UNITED STATES PATENT AND TRADEMARK OFFICE

Office Action Summary	Application No. 10/512,003	Applicant(s) BAMBACH, RAMON JOHN	
	Examiner Benjamin P. Lee	Art Unit 3641

DETAILED ACTION

FIG. 5
 O'Dwyer et al

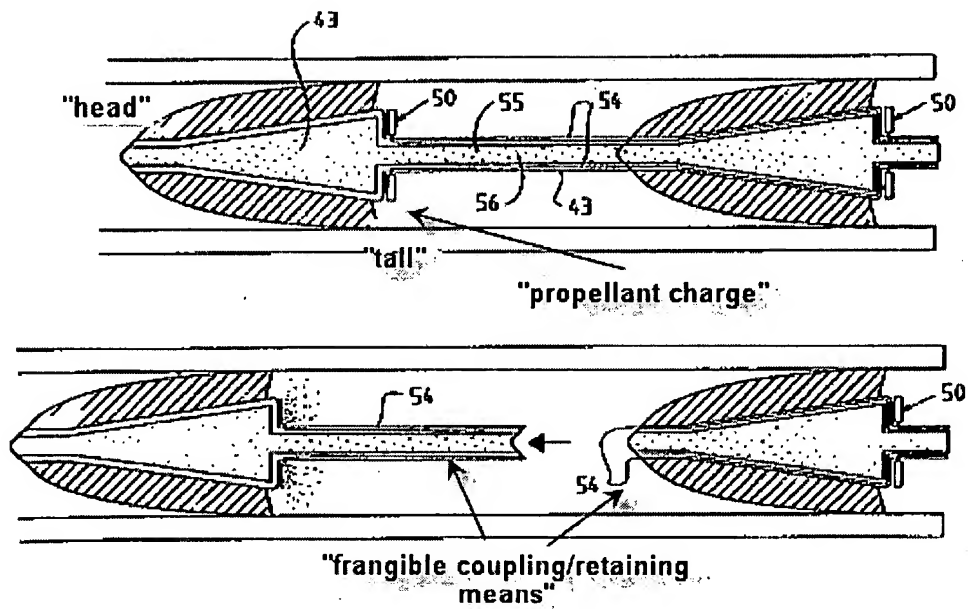
8. In regards to claims 22, 27, 41, 43 and 51, O'Dwyer et al disclose a projectile sealing arrangement including at least two projectiles coupled together by a frangible coupling (item 54 of O'Dwyer et al fig. 5 following) to form a chain, wherein: each projectile has a head portion, a tail portion and a propellant charge (see O'Dwyer et al fig. 5 following), the tail portion of the leading projectile and the head portion of the trailing projectile form a seal around the propellant charge of the leading projectile, and the coupling includes retaining means disposed between the tail portion of a leading projectile and the head portion of a trailing projectile (see O'Dwyer et al fig. 5 following). Note that the tail of the leading projectile and the head of the trailing projectile encompass the propellant charge of the leading projectile and form what constitutes a seal between them.

9. In regards to claim 23, O'Dwyer et al disclose the seal includes contact between complementary surfaces on the leading and trailing projectiles (see O'Dwyer et al fig. 5 following). Note that item 55 (column) contacts the head of the trailing projectile.

Tauschek et al

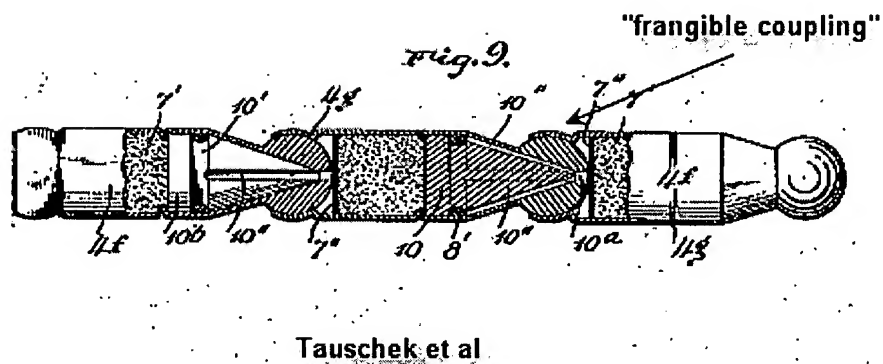
coupling (see Tauschek et al fig. 9 following: Note that the “ball” and “socket” disclosed by Tauschek et al in figure 9 constitutes a “frangible coupling” since they separate or “break”) to form a chain, wherein: each projectile has a head portion, a tail portion and a propellant charge (see Tauschek et al fig. 9 following), the tail portion of the leading projectile and the head portion of the trailing projectile form a seal around the propellant charge of the leading projectile, and the coupling includes retaining means disposed between the tail portion of a leading projectile and the head portion of a trailing projectile (see Tauschek et al fig. 9 following). Note that the tail of the leading projectile and the head of the trailing projectile encompass the propellant charge of the leading projectile and form what constitutes a seal between them.

12. In regards to claim 23, Tauschek et al disclose the seal includes contact between complementary surfaces on the leading and trailing projectiles (see Tauschek et al fig. 9 following).

13. In regards to claims 28, 30, 42, 52 and 54, Tauschek et al disclose the retaining means includes complementary spigot means and socket means engaged together. The spigot and socket means are provided on the trailing and leading projectiles respectively (see Tauschek et al fig. 9 following).
